Subject: UNIVERSITY VILLAGE AT LAKE DESIGN

ALTERNATE BUILDING/OPEN SPACE DESIGN
UNIVERSITY VILLAGE AT LAKE
JUNE 2017

UNIVERSITY VILLAGE AT LAKE
 AMENDED BATH ACCESS DESIGN
 WITH ACCESS FROM COMMON
 LIVING AREA / HALLWAY
 JUNE 2017 M. BELLUOMINI

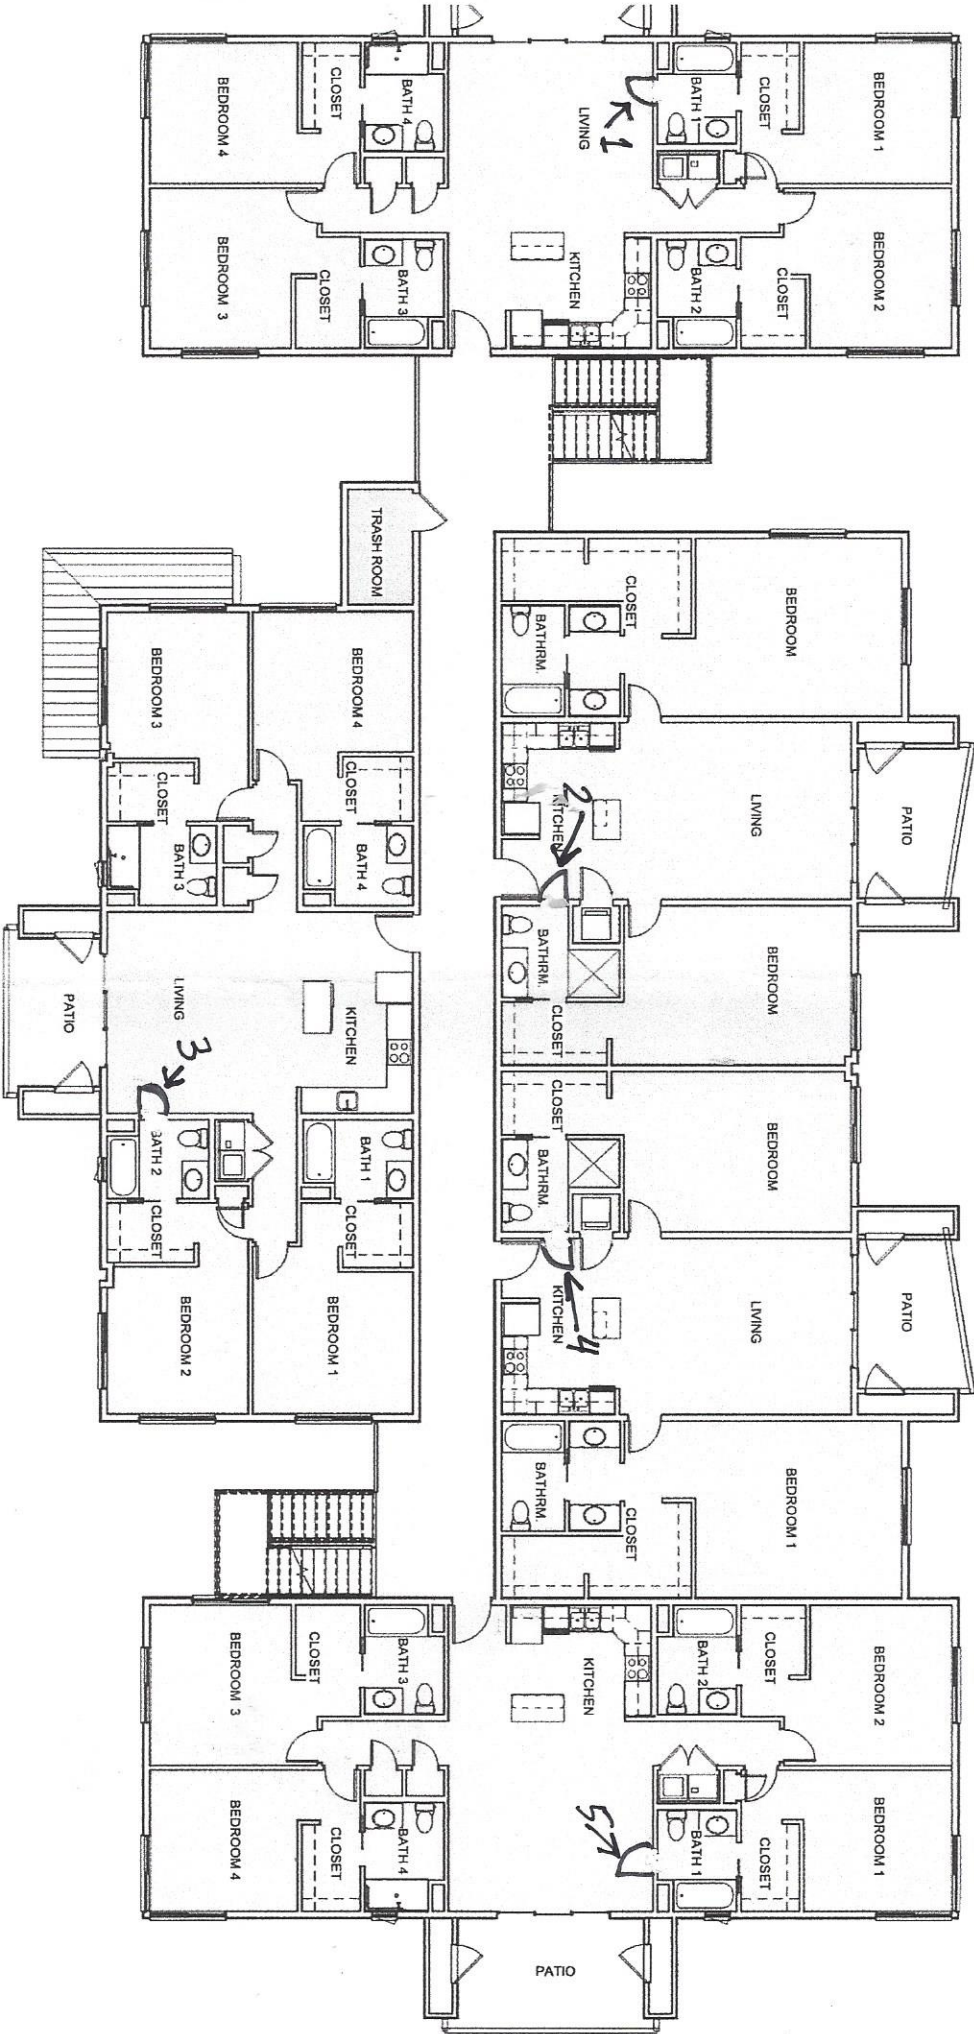
The first change is to achieve clustering of apartment buildings into groups that have an adjacent open space that seems like it belongs to those apartments. This improve security, safety, and development of neighbor relations that are better for residents. The current design north of the club house looks like "human filing cabinets". Buildings in a row with no relation to an outdoor space, focal point, or gathering place near to and unique to those buildings. The alternate design incorporates courtyards A, B, & C in addition to the pool clubhouse gathering area. It also relocates the basketball court so it is surrounded by apartments rather than at the far end of the complex away from most apartments that might use it. This is in keeping with the new zoning ordinance design guidelines for apartments. The developer should be complimented for following the guideline to provide every unit with a balcony. More improvements can be made.

The second change is to improve the solar exposure so that balconies and windowed rooms have good sunlight without glare and excess heat gain. In the original design seven (7) of the apartment buildings face east-west, so that they have glaring hot sun in the afternoon or morning coming in at a low angle. This makes balconies less useable. In the design alternative only three of the buildings face east-west while the other 12 face generally north-south. North-south facing windows and balconies receive sunlight but in the summer the angle of the sun is high so roof overhangs create shade successfully. In the winter when the sun is low in the sky the south facing units receive sunlight during a cold and dark time of the year, thereby improving the living environment.
